PCI-SIG ENGINEERING CHANGE NOTICE

TITLE:	Power-up requirements for PCIe side bands in a Vbat powered system
DATE:	October 20, 2014
AFFECTED DOCUMENT:	PCI Express M.2 Specification, Revision 1.0, as revised by "Power-up requirements for PCIe side bands (PERST#, etc.)" ECN.
SPONSOR:	Stefan Nilsson, Ericsson; Dave Landsman, SanDisk; Ramdas Kachare, LSI

Figure 79a. Power-Up Timing Sequence for a module powered from a 3.3V power rail

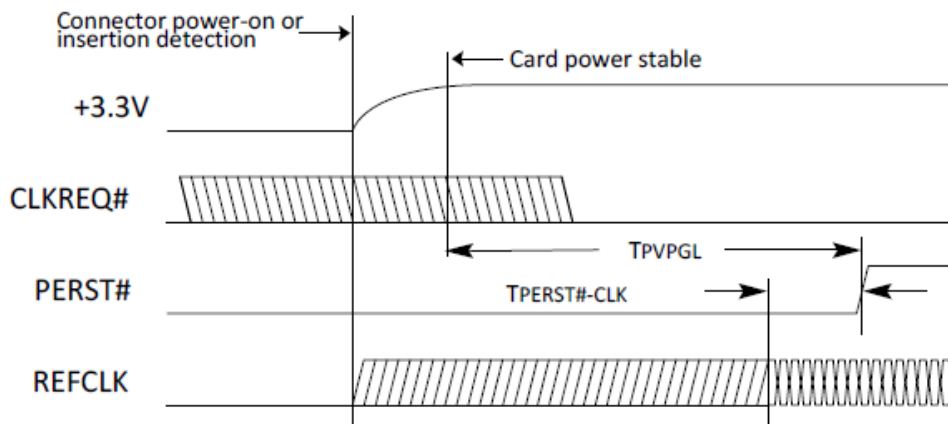
Figure 79a provides an overview of the M.2 device power up sequence for a module powered from +3.3 V power rail, while Figure 79b provides an overview of the M.2 power up sequence for a module powered by a direct VBAT connection. In the case of a direct VBAT connection, the de-assertion of FULL_CARD_POWER_OFF# triggers start of the module power-up sequence. It is assumed that VBAT will be within its specified voltage range (see section 4.3) well before FULL_CARD_POWER_OFF# becomes de-asserted. See section 3.2.10.1 for details about the FULL_CARD_POWER_OFF# signal. Table 16 lists the power-up timing variable values.

The host shall delay de-assertion of PERST# for a period of time (T_{PVPG}L) after power is stable on the card (see Figure 79a or Figure 79b). See section 3.1.3.4 for further details on PERST#.
